IN no.: **IN-142 rev 1.1**

Date: **2021-10-11**

nRF52832-QFAA, nRF52832-QFAB and nRF52832-CIAA

Description of change:

Marking/Shipping labels:

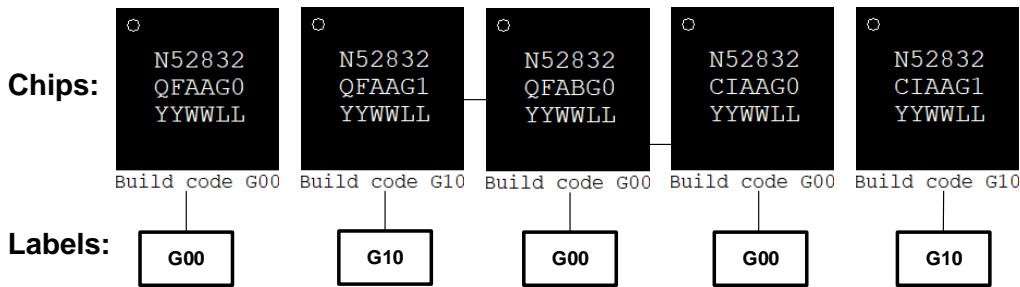
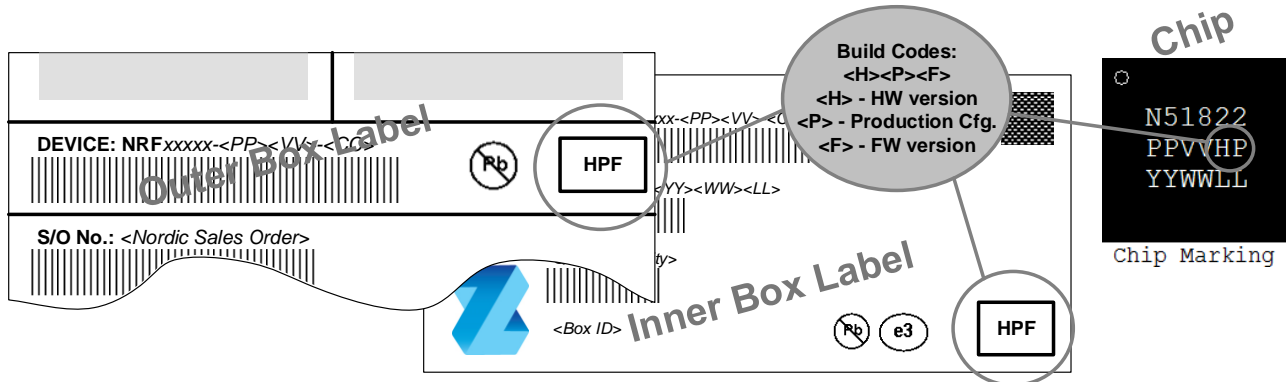
The nRF52832 revision 3 (build codes Gx0) introduces behavioral changes, as well as new/modified registers to the access port protection. All new registers and changes in functionality for revision 3 are documented in the nRF52832 product specification rev 1.7 and the errata document.

Customers who want to take advantage of the changes introduced in revision 3 will need to place orders via separate ordering codes (nRF52832-QFAA-G, nRF52832-QFAB-G and nRF52832-CIAA-G). Production of revision 2 (build code Ex0) is maintained and is ordered using the existing ordering codes (nRF52832-QFAA, nRF52832-QFAB and nRF52832-CIAA).

Build code – Gx0
